SUBSURFACE WASTEWATER DISPOSAL SYSTEM APPLICATION

Town Or Plantation	Augusta
Street Subdivision Lot #	Bog Road

Last: Szela First: Michael E.

Re: Relocation of Proposed Subsurface Wastewater Disposal System, Michael Szela Property, Bog Road, Augusta.

SUBSURFACE WASTEWATER DISPOSAL PLAN

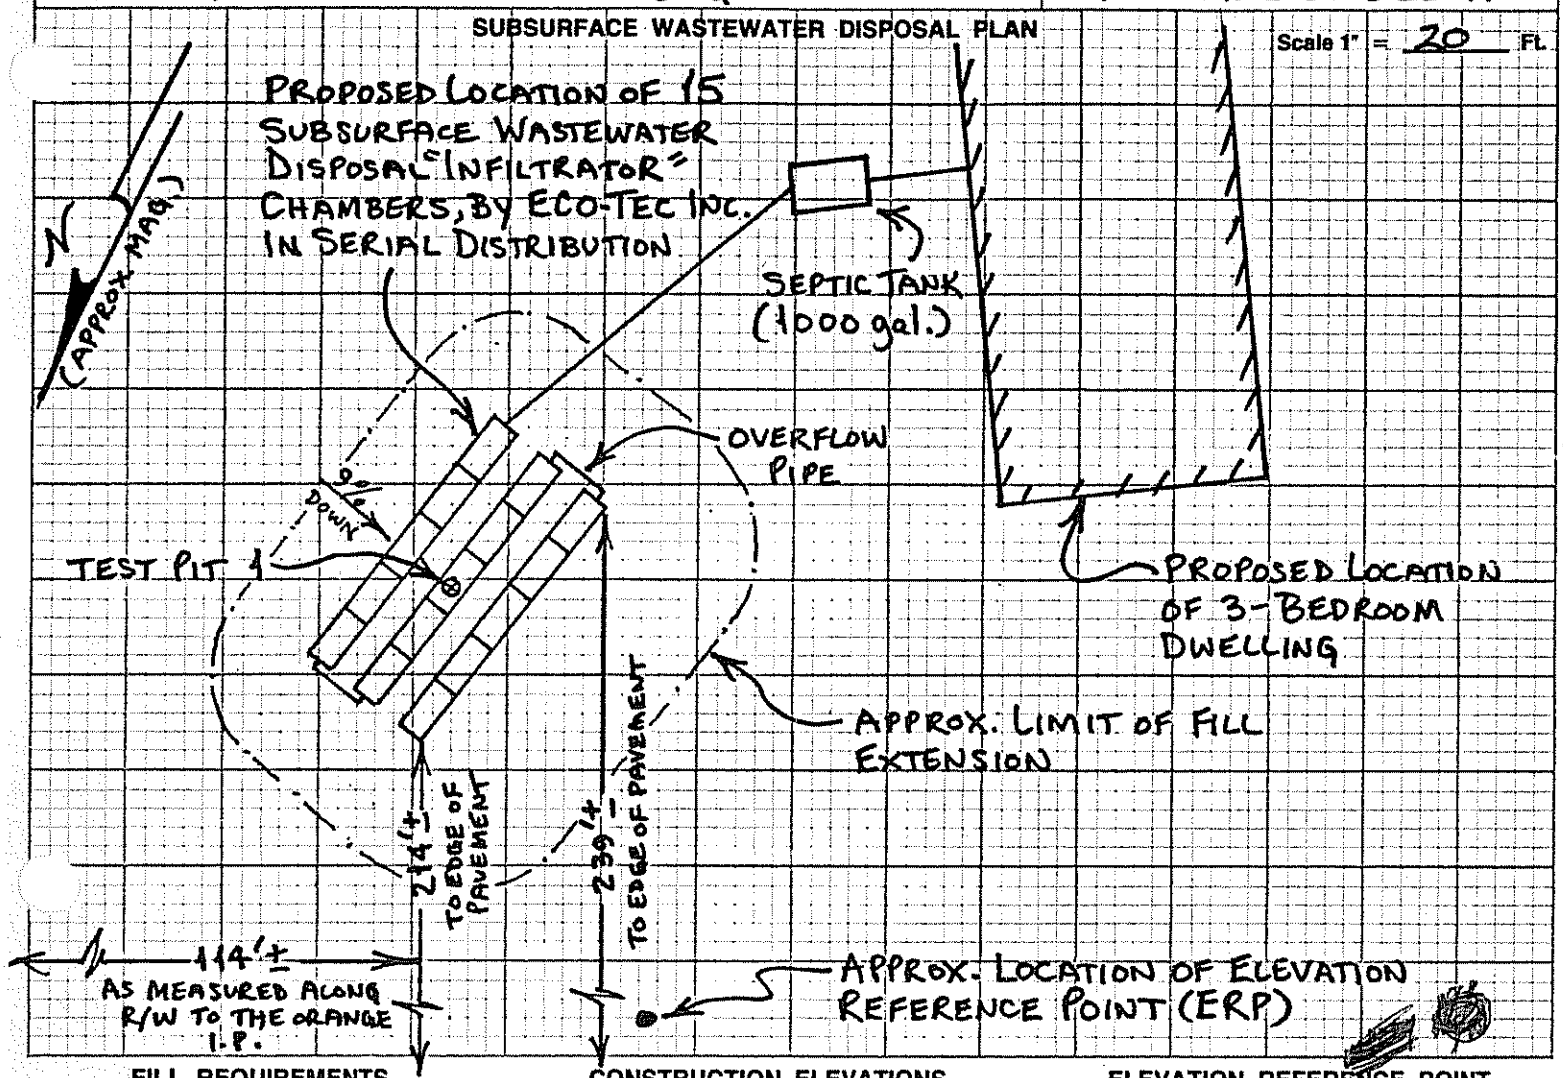
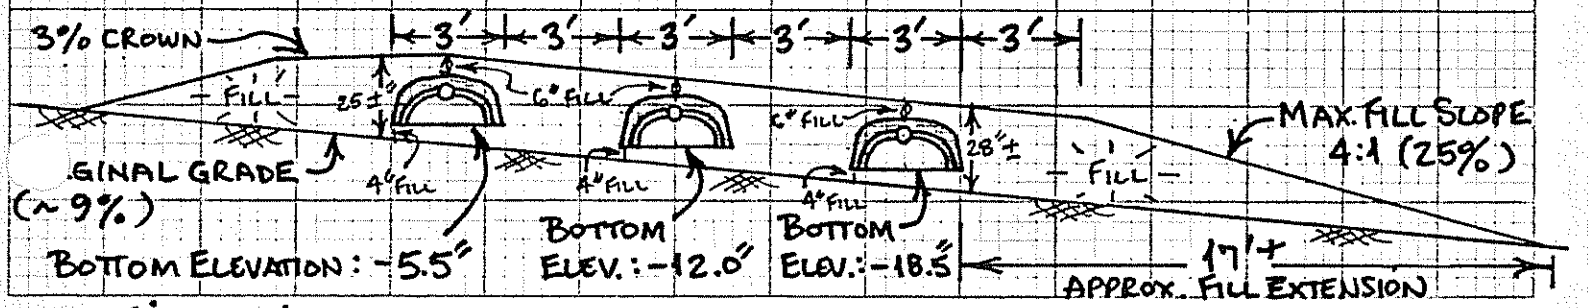
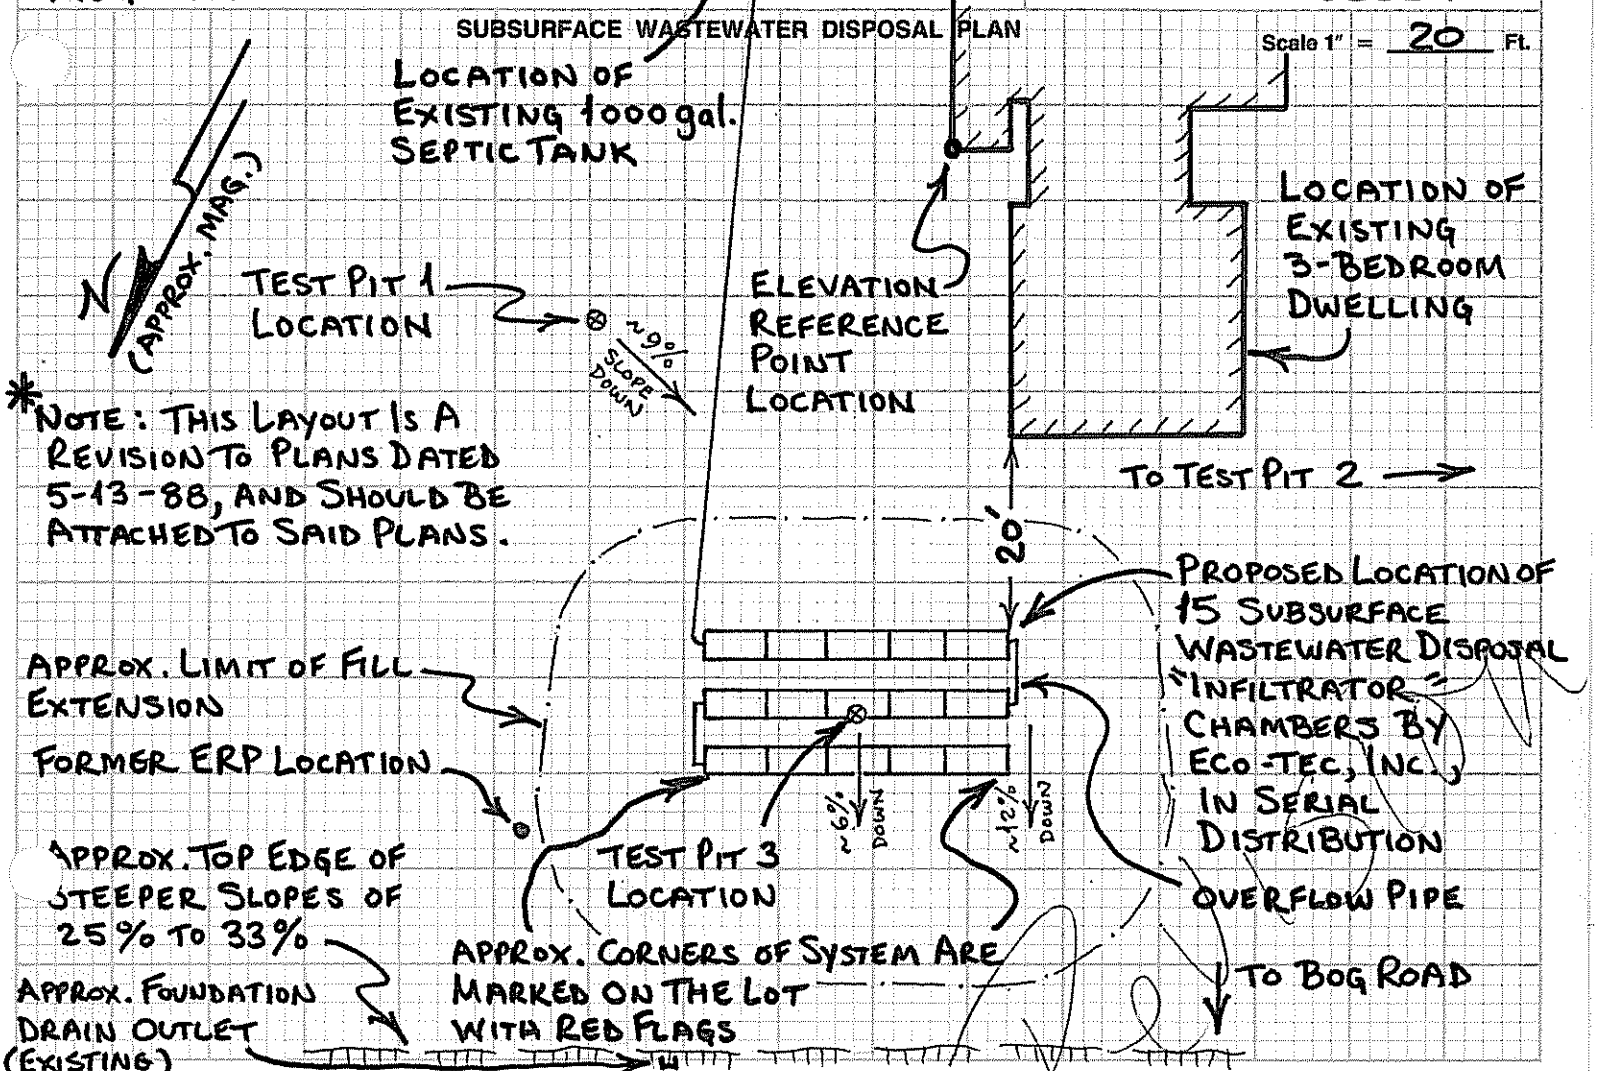
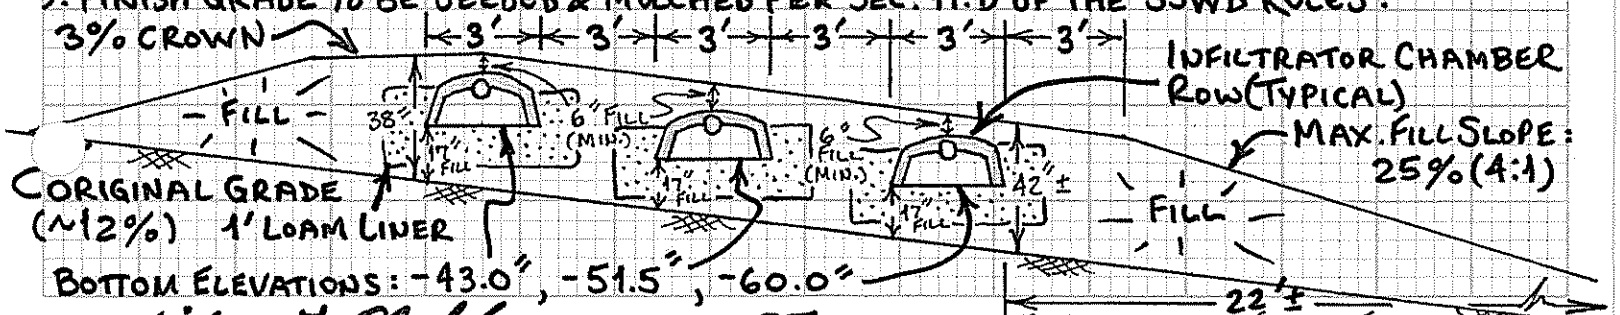
This letter is in respone to our telephone conversation on June 8, 1988, in regard to revising the location of the subsurface wastewater disposal system area for the Michael Szela property from that proposed in the Subsurface Wastewater Disposal System Application (HHE-200 form), dated 5/13/88.

The subsurface wastewater disposal area relocation involves shifting the area 12 feet downslope, based on conversations with both Michael and Ellen Szela. The purpose is to provide for a lowering of the system at least 12" from that originally designed, to insure gravity flow of sewage to the disposal area.

Relocation of the subsurface wastewater disposal area will leave test pit 1 outside of this area. However, evaluation of a number of test pits in the vicinity of the building site revealed that the soil profile and conditions are reasonably consistent in this area. An additional test pit in the new area for the disposal system may not be all that helpful since much of the area has now been bulldozed, and the original ground level has been lost.

It is important to establish revised elevations for each chamber row of the subsurface wastewater disposal system, that relate back to test pit 1, at which the original soil surface elevation was determined. The row lowest in elevation in the original 5/13/88 design plans is proposed to become the row highest in elevation for the relocated system, and the elevation of its bottom will remain unchanged at -18.5". There is an approximate 6.5" drop between each chamber row, based on an average ground slope of 9%. Therefore, the bottom elevation of the next two rows are to be -25.0", and -31.5", respectively.

2.) THIS SOIL PROFILE DATA (TP 3) WAS USED TO DEVELOP A SUBSURFACE WASTEWATER DISPOSAL SYSTEM LAYOUT REVISING PLANS DATED 5-13-88, AND SHOULD BE ATTACHED TO SAID PLANS.

SUBSURFACE WASTEWATER DISPOSAL PLAN

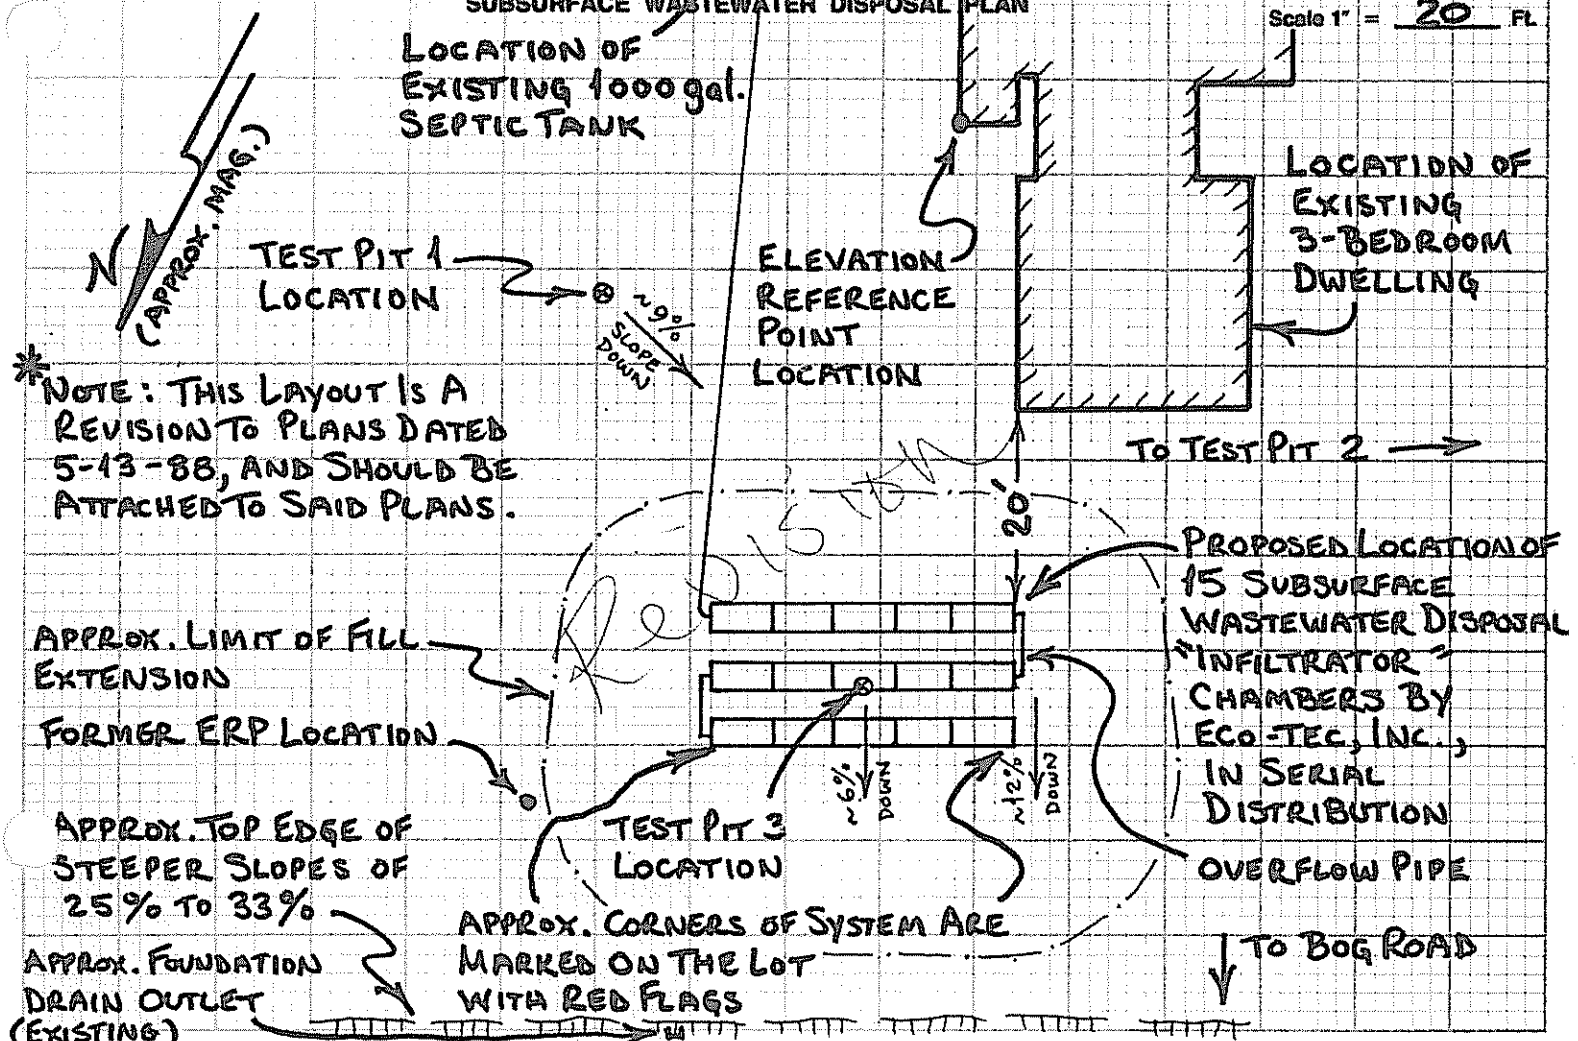
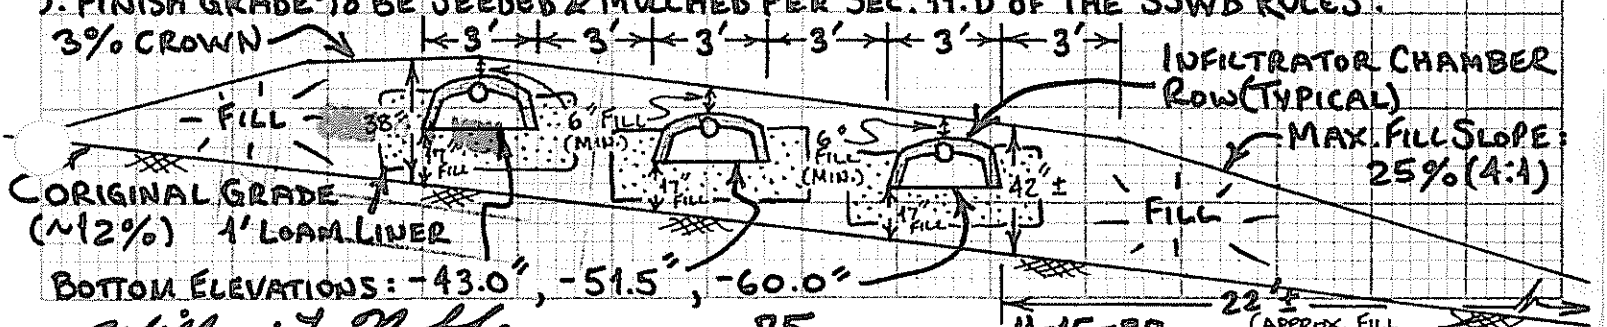
2.) THIS SOIL PROFILE DATA (TP 3) WAS USED TO DEVELOP A SUBSURFACE WASTEWATER DISPOSAL SYSTEM LAYOUT REVISING PLANS DATED 11-18-88, AND SHOULD BE ATTACHED TO SAID PLANS.
